Access Compliance Report

Public Rights-of-Way

(Curb Ramps)

Intersection ID: 15489	Main Street: HARVARD_PL	Cross Street: QUEENS_RD	Location:	E
ADA ID: FDD7E7FE27BB	Ramp Type: Perp	Initial Pass/Fail: Fail	Overall Compliance: No	Severity Score: 85

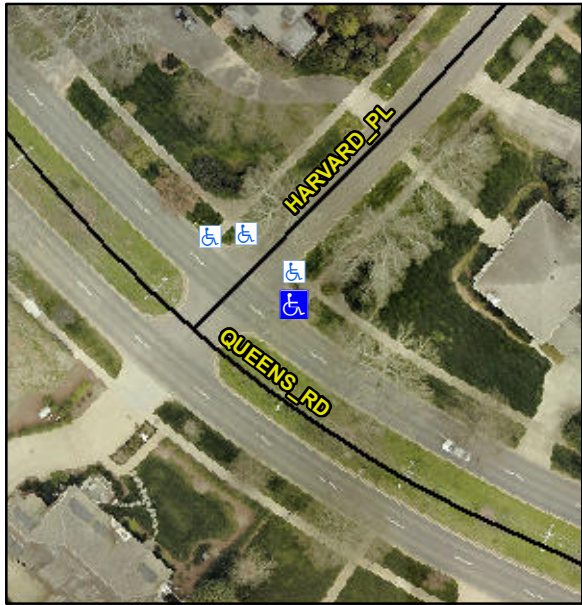
Codes/Mitigation Info/Possible Solution			Field Measurements/Component Compliance					
	Possible Solutions:		Compliance	Description	Data	Compliance	Description	Data
	Remove & Replace Entire Ramp.		N/A	Ramp Length (in)	68.0	No	Ramp Slope (%)	15.7
			No	Ramp Width (in)	27.0	No	Ramp XSlope (%)	13.6
			N/A	Flare Type LT	N/A	N/A	Flare Type RT	N/A
			N/A	Flare Slope LT (%)	N/A	N/A	Flare Slope RT (%)	N/A
			N/A	Flare Traversable LT?	N/A	N/A	Flare Traversable RT?	N/A
			N/A	Landing Length (in)	N/A	N/A	DWS Provided?	N/A
			N/A	Landing Width (in)	N/A	N/A	DWS Contrast?	N/A
			N/A	Landing Slope (%)	N/A	N/A	DWS Length (in)	N/A
			N/A	Landing X Slope (%)	N/A	N/A	DWS Full Width?	N/A
Surveyor Notes:			N/A	Landing Curb? (Y/N)	N/A	N/A	DWS Offset (in)	N/A
N/A			N/A	Shared Landing?	N/A			
PROW/ADA:			N/A	Gutter Ponding?	N/A	N/A	Gutter Slope (%)	N/A
Not Found, R304.5.1, R304.2.2, R304.5.3			N/A	Gutter Lip Ht (in)	N/A	N/A	Gutter X Slope (%)	N/A

N/A	Painted X Walk1?	No	N/A	Painted X Walk2?	N/A
				X Walk 1 Direction	To SW		X Walk 2 Direction	N/A
			N/A	X Walk 1 Width (in)	N/A	N/A	X Walk 2 Width (in)	N/A
				X Walk 1 Slope (%)	3.7		X Walk 2 Slope (%)	N/A
				X Walk 1 X Slope (%)	2.1		X Walk 2 X Slope (%)	N/A
			N/A	Ramp inside XWalk1?	N/A	N/A	Ramp inside XWalk2?	N/A
				Road Slope (%)	N/A	N/A	Clear Space?	N/A
				Road X Slope (%)	N/A	N/A	Clear Space to XWalk (in)	N/A
			N/A	Any Obstructions?	N/A	N/A	Storm Grate/Utility Hazard?	N/A
				Obstruction Type			Storm Grate/Utility Type	
						N/A		N/A
						Yes	Surface Condition? (G/P)	Good
